AGENDA
Regular Hybrid Meeting
Town of Granby
Planning & Zoning Commission
Tuesday, July 8, 2025, at 7:00 pm
Town Hall Meeting Room

MEETING MINUTES
Town of Granby
Planning & Zoning Commission
Tuesday, June 24, 2025, at 7:00 pm

Subdivision Application Plan Review
June 27, 2025

Breezy Meadow Subdivision, Prepared for Peak Mountain Development, LLC, 188 Day Street, December 23, 2024, Sheets: SD-1, GR-1, GR-2 E&SC-1, E&SC-2, Notes-1, Alford Associates, Inc., last revised 6/04/25.”

Sheet
SD-1

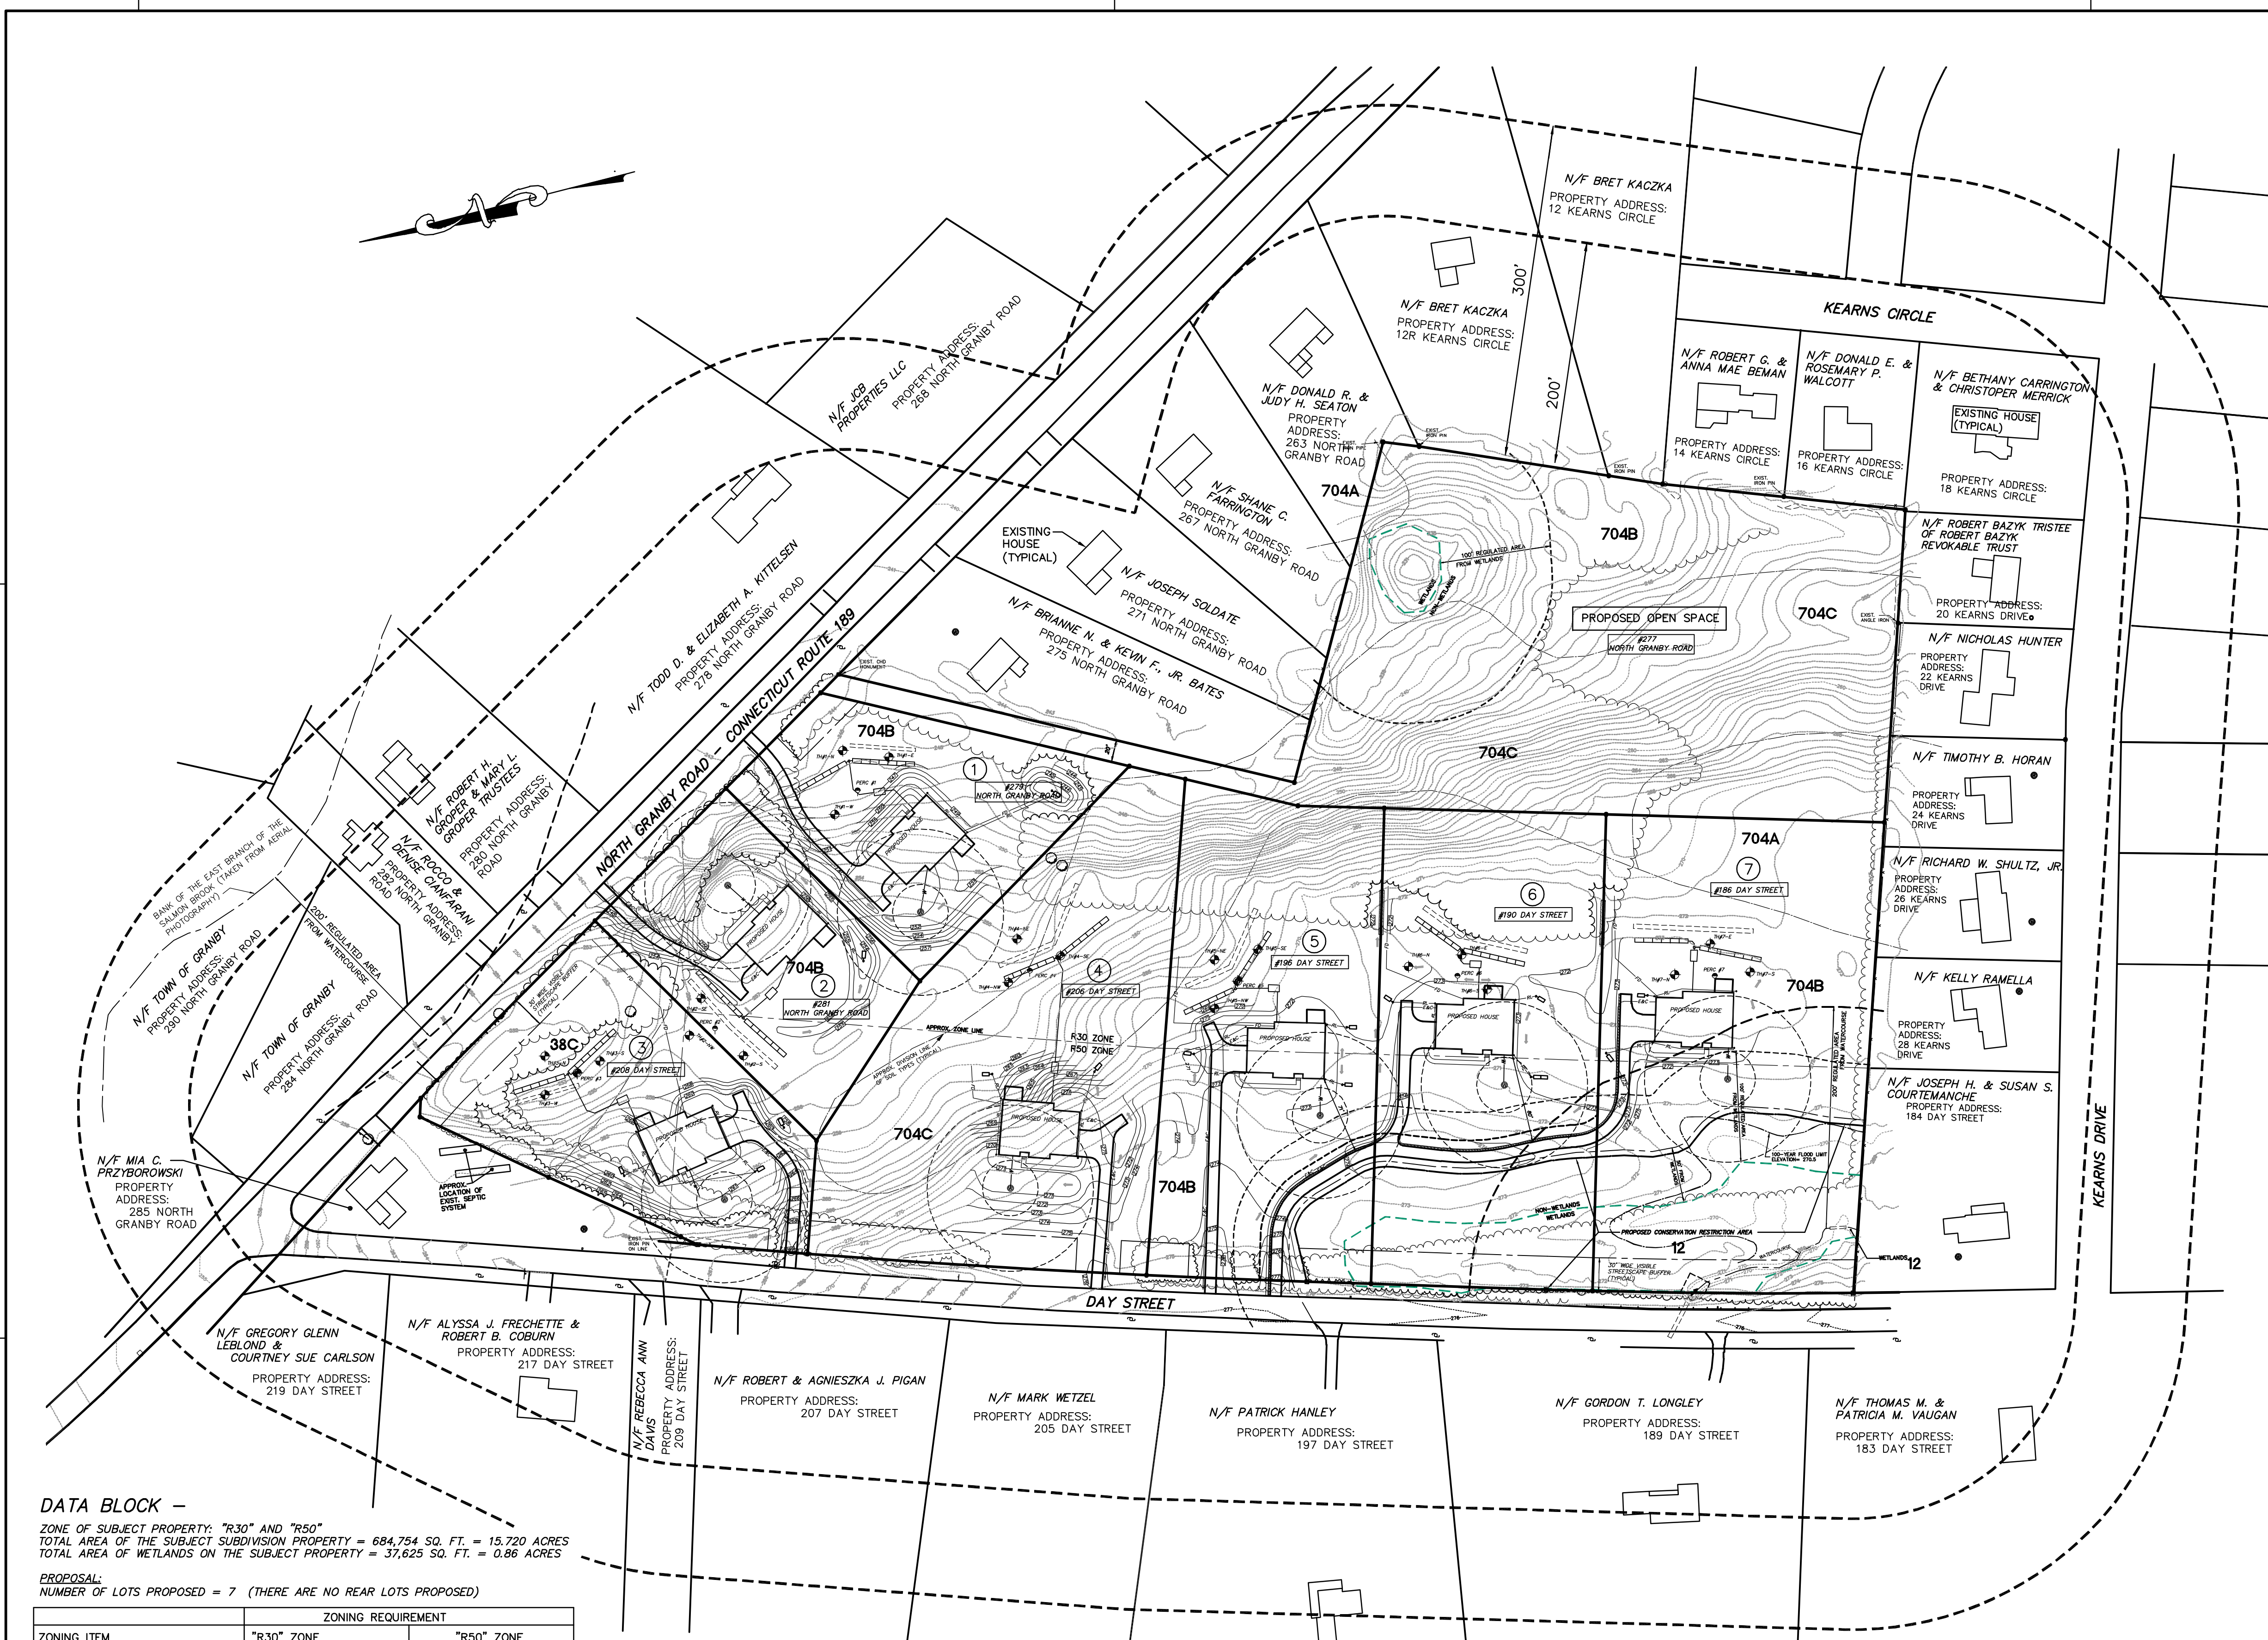
1. Show angle to chord(s) for the street line curve on Day Street so that the lots can be mathematically closed.
2. Map legend required.
3. Show street line on west side of road. Are there any surveys or property markers? Want to keep the new street line on the east side of the road parallel to any established line on the west side.
4. Are the rectangles shown on the west street line, monuments to be set?

12. Add a detail showing the construction of the driveways from the edge of road to the street line as described in section 4.13 of the subdivision regulations

13. Reprint page 1 of the Hydraflow Report. The drainage schematic does not appear on the sheet.
14. Eliminate the rain garden/basins shown on lots 1,2,3,5, and 6. Stormwater from non-impervious areas should be allowed to sheet drain. Infiltration systems for the roof drains shall be sized

according to the manufacturer's instructions. Soil test holes may be required at or in the vicinity of the infiltration areas if the excavation for the basements show a different soil profile.
